**BID No. 24-25-09 Bridge 3121 Replacement Project on San Juan County Road  
3000**

**ADDENDUM #2  
November 6, 2024**

ADDENDUM NO. 2

PROJECT NAME: Bridge 3121 Replacement Project on San Juan County Road 3000

**CR3000 - SOUTHSIDE RIVER RD 'CORDELL' BRIDGE WING WALL REPAIR CONSTRUCTION DRAWING PLAN AND DETAILS SHEET**  
**S-101**

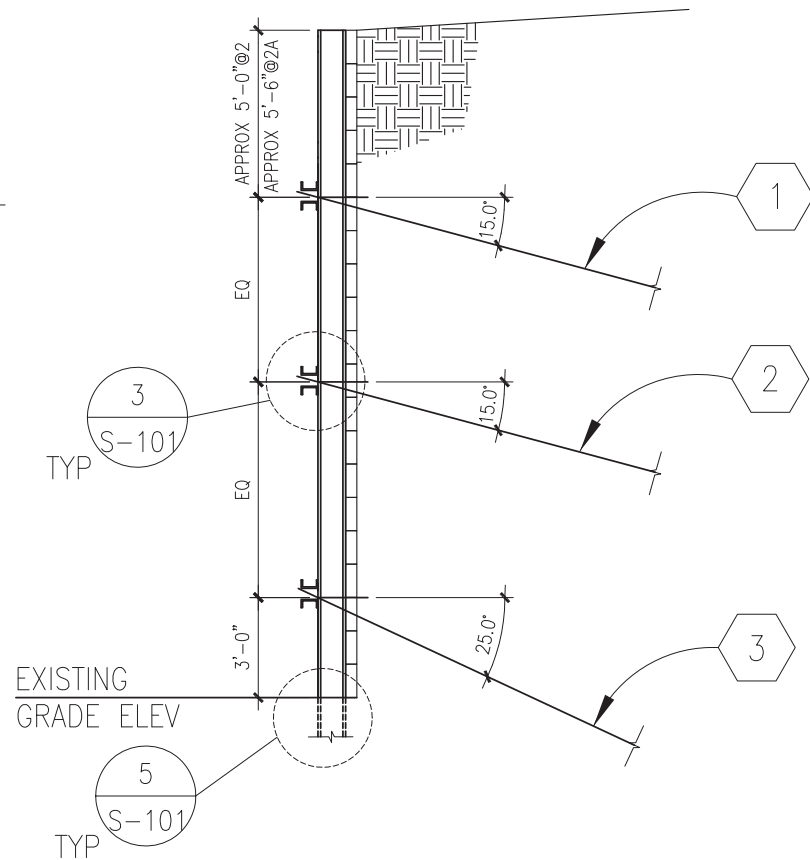
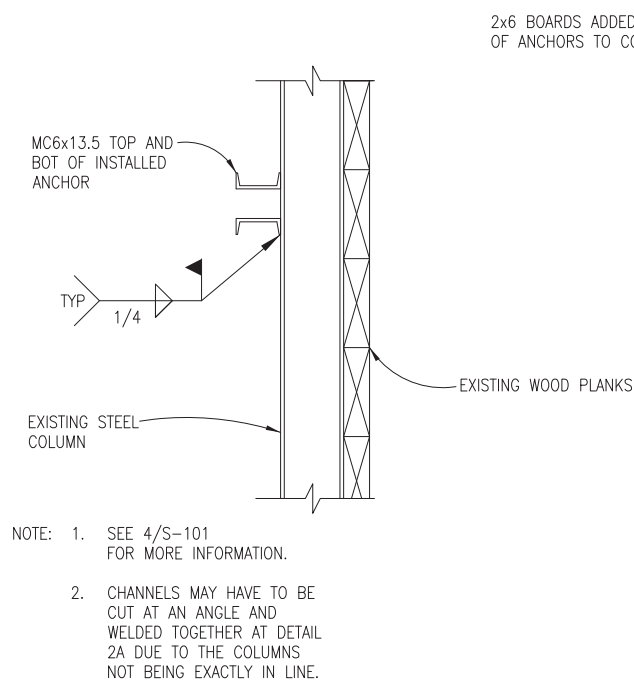
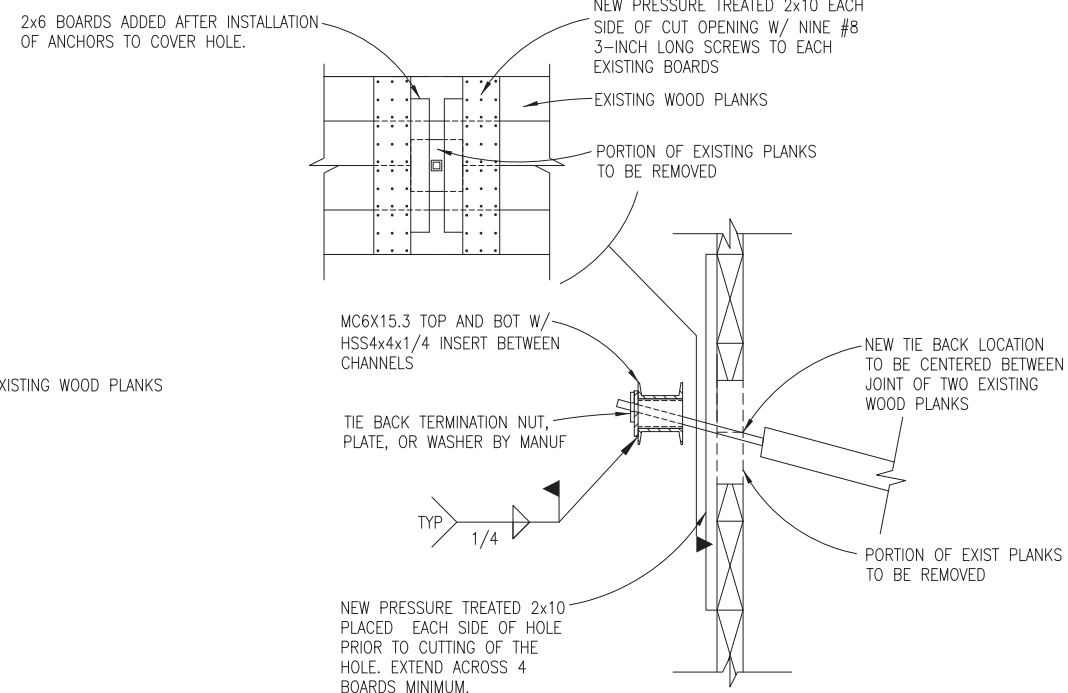
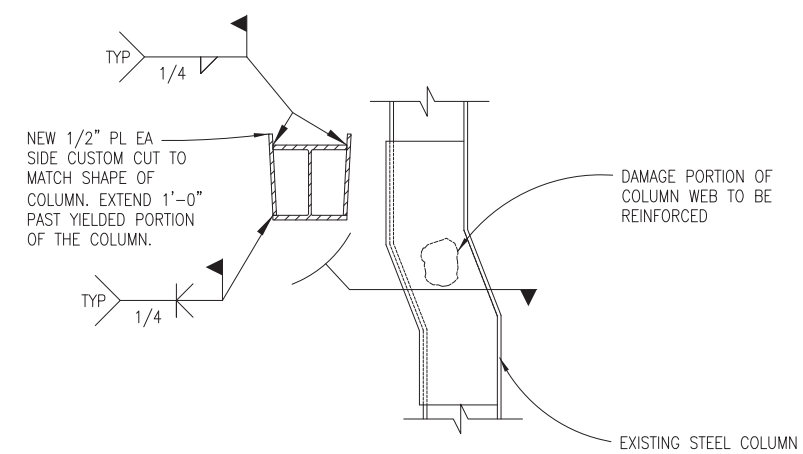
- 2. Question: We are requesting the as-built drawings as well as the roadway and channel cross sections for the Bridge 3121 Replacement Project on San Juan County Road 3000 be made available prior to bid. Thank you for your time.**

- 3. Question: Will as built drawings for the Bridge 3121 Replacement Project on San Juan County Road 3000 be made available prior to bid?**

Response: We do not have as-built drawings to share. What can be shared are the limited design drawings the County has been able to find for the bridges. Bridge 3121 has a design for a wing wall stabilization project from 2011. See the attached drawing for your use. There are not any prepared roadway or channel cross sections prepared at this time. Cross sections can be provided to the selected contractor upon award.

Response: See the attached drawing, this is all of the information the County has on the existing bridge.

**SECTION A**

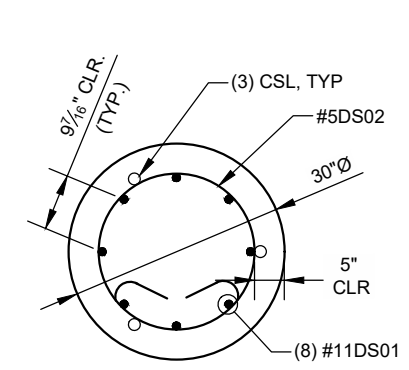
- 5. Question: Drilled Shaft (Section A/05-5) – Section cut shows 8#11 verts but bar list shows 16#11 verts per cage. Which are we to follow?**

Response: See the updated drawing. 8 #11 vertical bars per cage.
